ORDER R5-2012-0067

AMENDING WASTE DISCHARGE REQUIREMENTS ORDER R5-2006-0037  
FOR  
GUENOC WINERY, INC.  
GUENOC WINERY  
LAKE COUNTY

ATTACHMENT C (AMENDED BY ORDER R5-2012-0067)

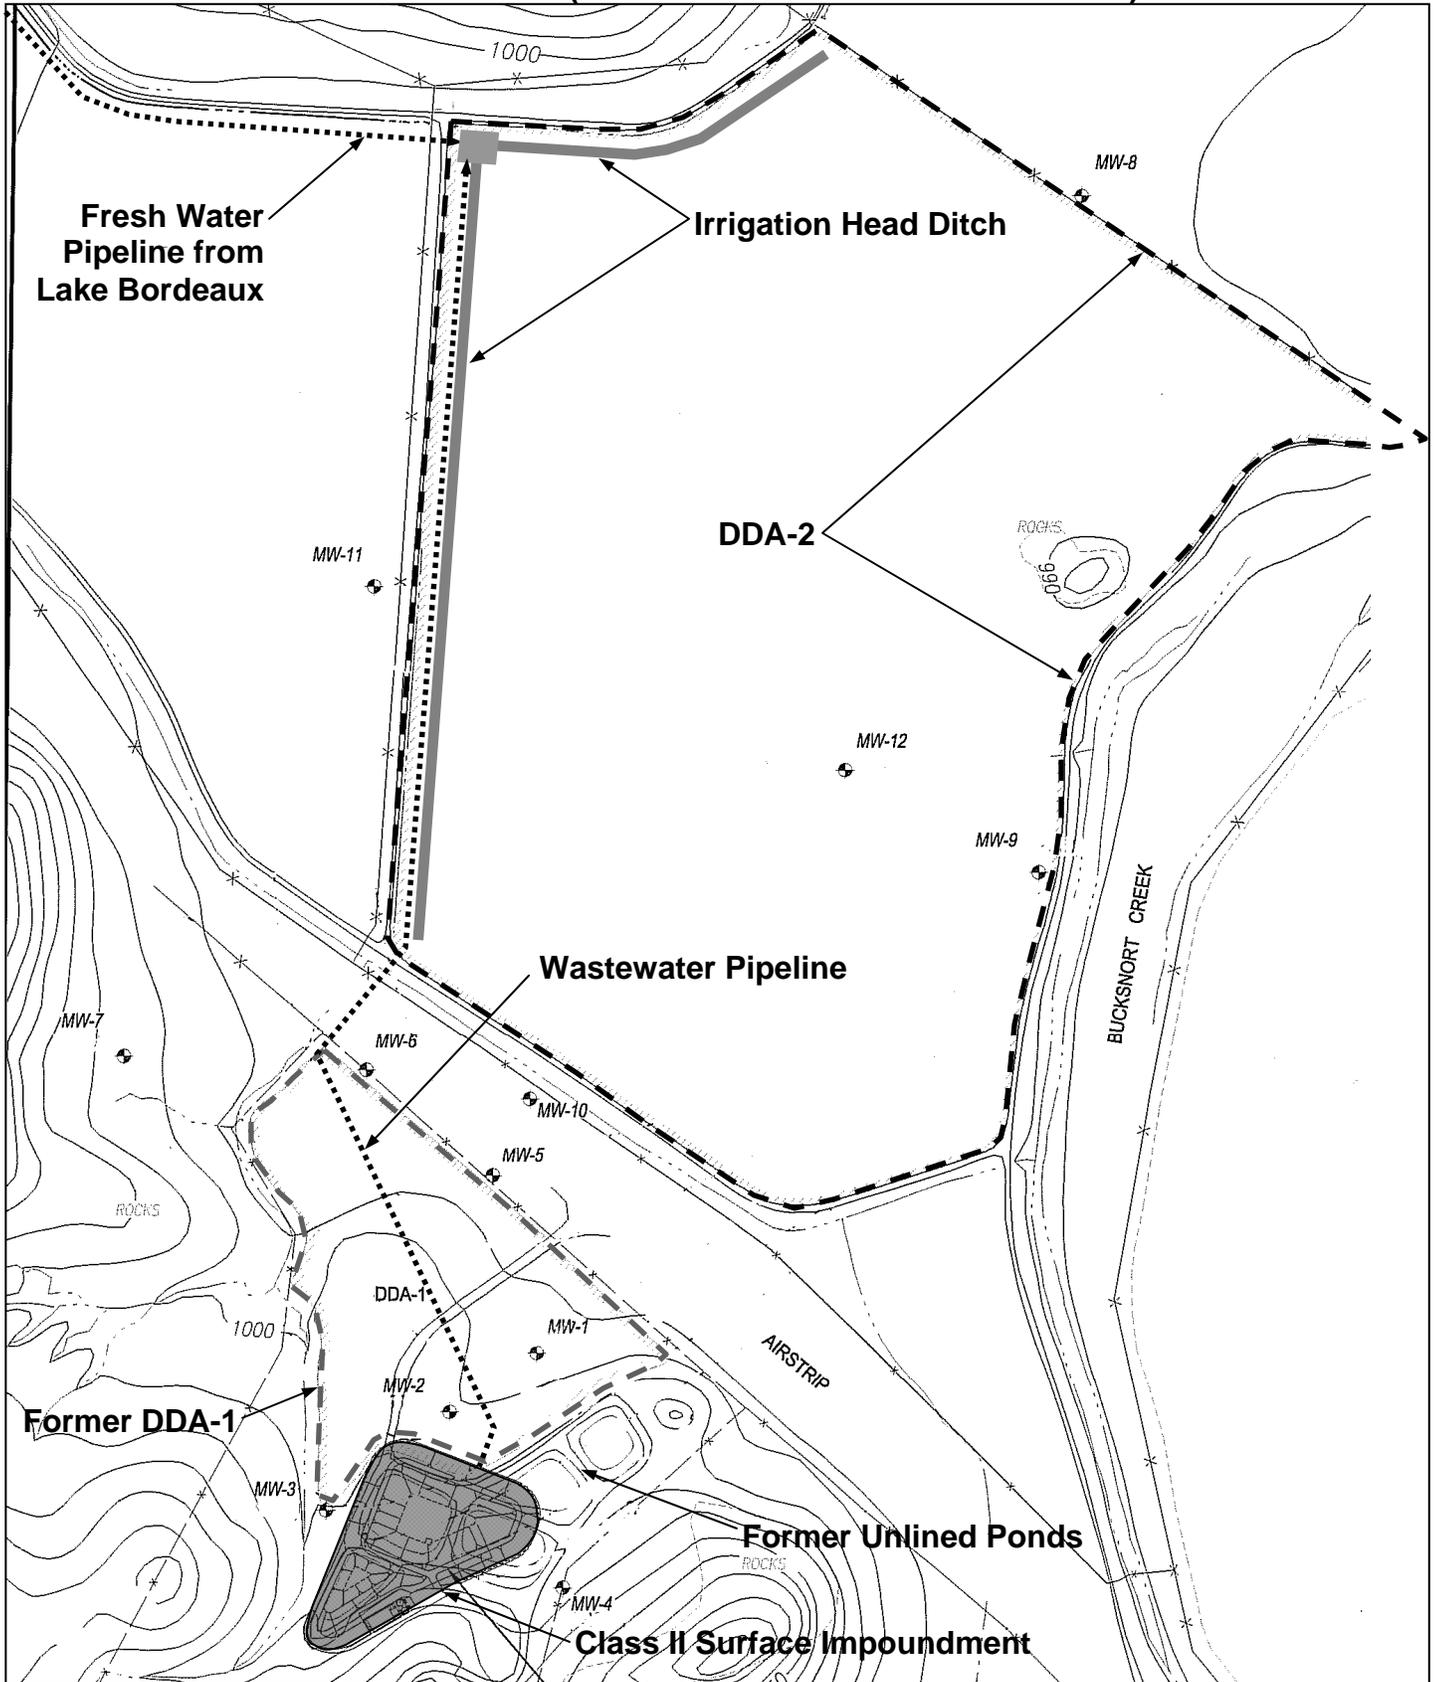
3. Attachment C, which is attached hereto and forms part of this Resolution, replaces the site plan included as Attachment C of the WDRs.
